UNITED STATES PATENT AND TRADEMARK OFFICE

APPLICATION NO.	FILING DATE	FIRST NAMED INVENTOR	ATTORNEY DOCKET NO.	CONFIRMATION NO.
09/812,655	03/19/2001	Stephen C. Schulz	35013.5100	2511

Office Action Summary

DETAILED ACTION

FIG. 6

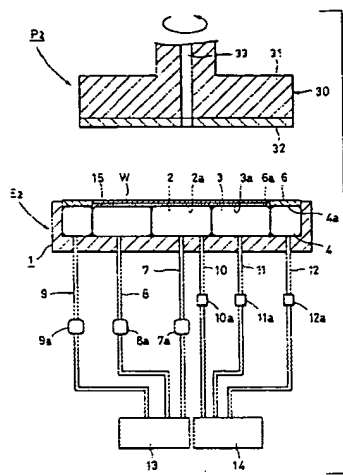
With reference to Fig. 6, col. 6, line 50 to col. 7, line 23, Takahashi teaches a rotational vibratory polishing motions being applied to a wafer. However, Takahashi is silent about the amplitude and frequency of the vibration.

With reference to col. 1, line 55 to col. 5, line 15, Rhoades teaches that it is known to have utilized high frequency/low amplitude vibrational polishing in combination with a slurry to obtain a high surface finish polish without the loss of resolution or detail.

Thus, it would have been obvious to one having ordinary skill in the art at the time the invention was made to have modified the method of polishing in Takahashi with the teaching of high frequency/low amplitude vibrational polishing as taught by Rhoades, since Rhoades states at col. 3, lines 55-61 that such a modification would obtain a high surface polish without the loss of resolution or detail.

Regarding to the range of amplitude and high frequency set forth in the claims, it would have been obvious to one having ordinary skill in the art at the time the invention was made to have utilized such range, since it has been held that where the general conditions of a claim are disclosed in the prior art, discovering the optimum or workable ranges involves only routine skill in the art.
